**Subject: WATTS BAR NUCLEAR PLANT (WBN) UNIT 2 – REQUEST FOR  
ADDITIONAL INFORMATION REGARDING FINAL SAFETY ANALYSIS  
REPORT (FSAR) AMENDMENT RELATED TO SECTION 9.5.1 “FIRE  
PROTECTION SYSTEM” (TAC NO. ME3091)**

### Response to NRC's Request for Information Regarding Final Safety Analysis Report Amendment Related to Section 9.5.1, "Fire Protection System"

**FIGURE III-1  
INTERACTION ANALYSIS FLOW CHART**

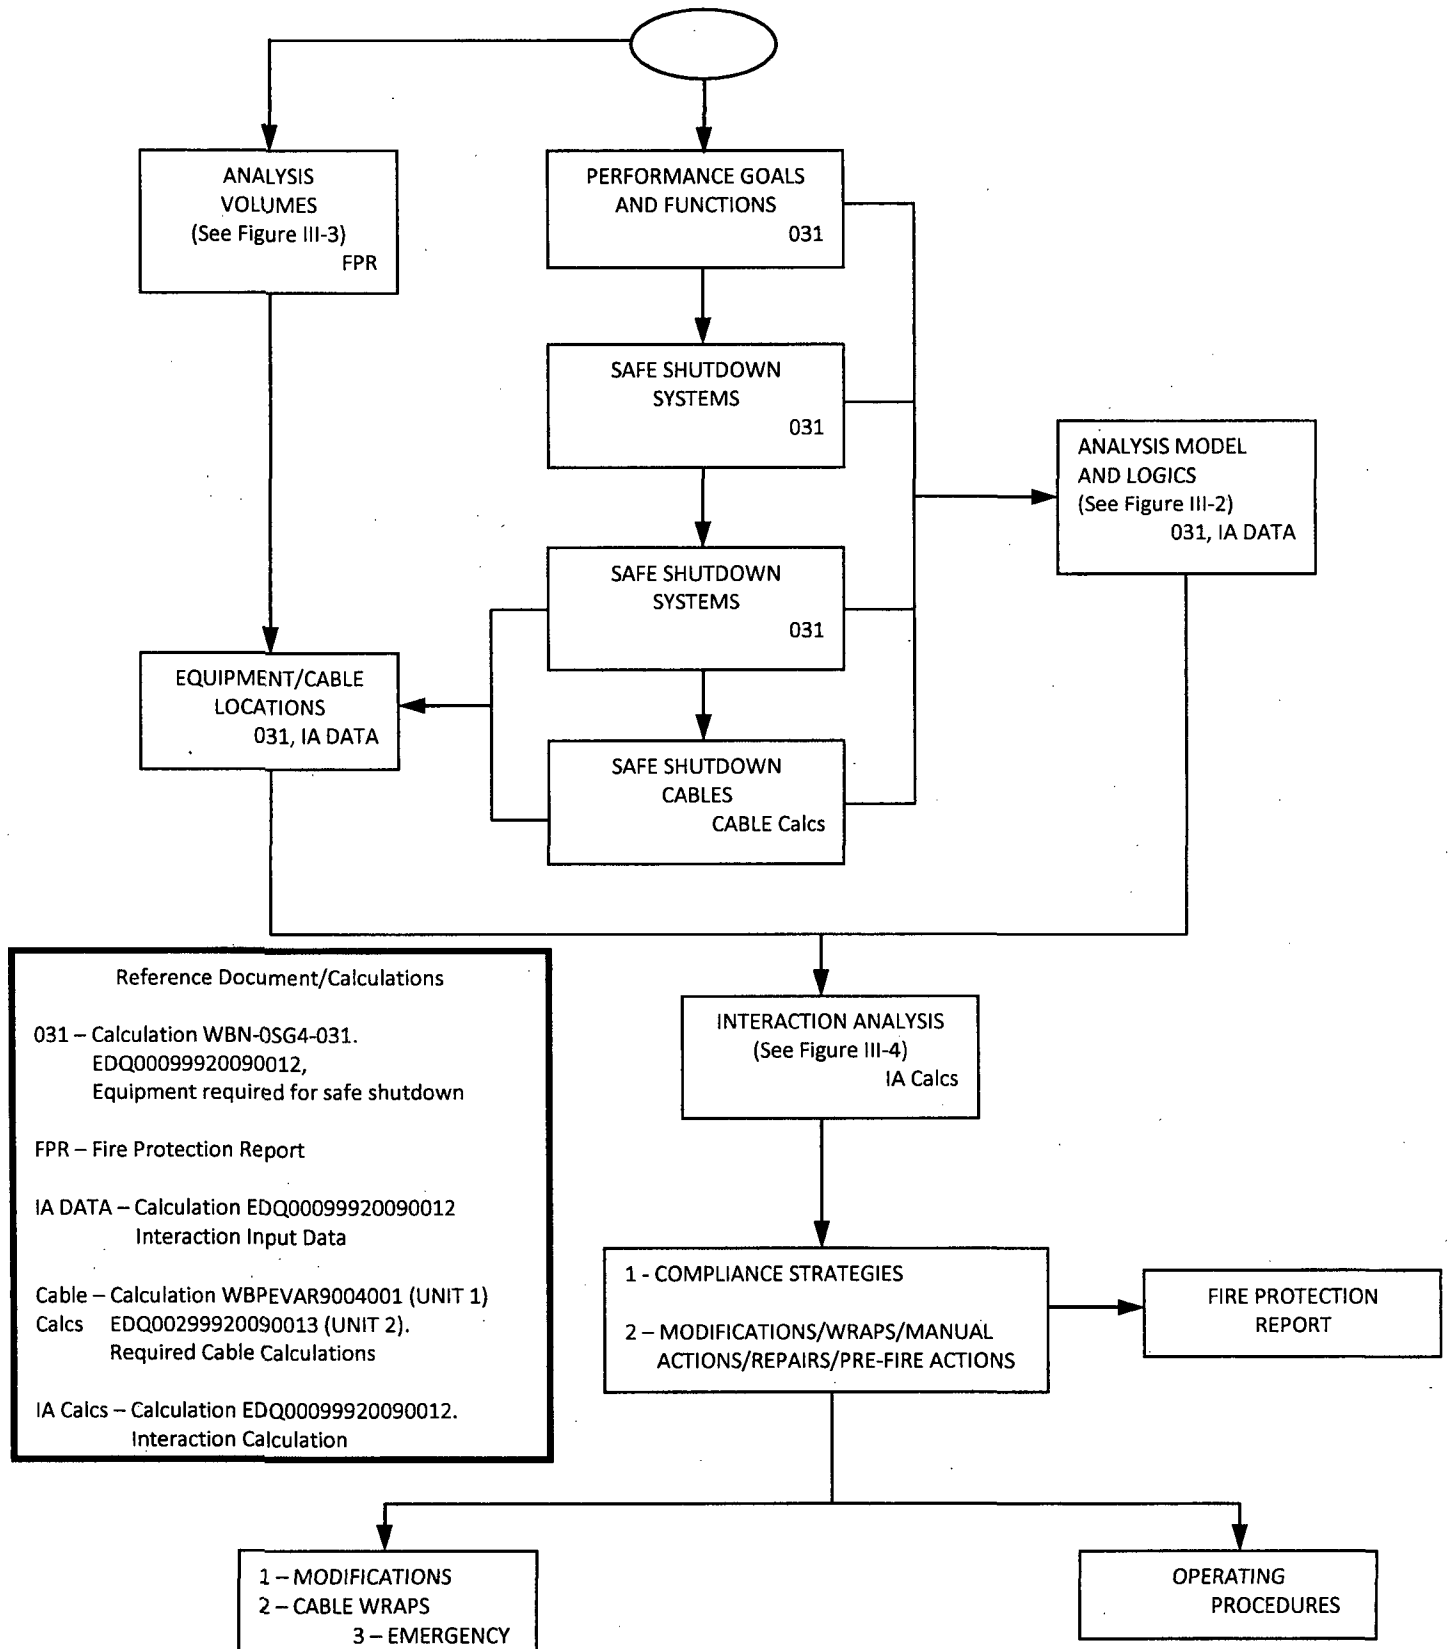
**[A]** Describe how the Unit 2 changes are represented in the as-designed versions of Figures III-1 through III-5 in Part III of the FPR. **[B]** Also, provide the as-designed versions of the Figures for Part III.

**[A]** The figures (Figures III-1 to III-5) are applicable to Unit 2 also. There is no change to the methodology for performing the combined unit's fire safe shutdown analyses. The "Reference Document and Calculations" box on Figures III-1 and III-2 has been revised to document the calculations for the dual unit's analyses. There is no change to Figures III-3, III-4, and III-5.

**[B]** A copy of the revised figures is attached (see Attachment 3) and they are included in Part III of the FPR that will be submitted by March 16, 2011.
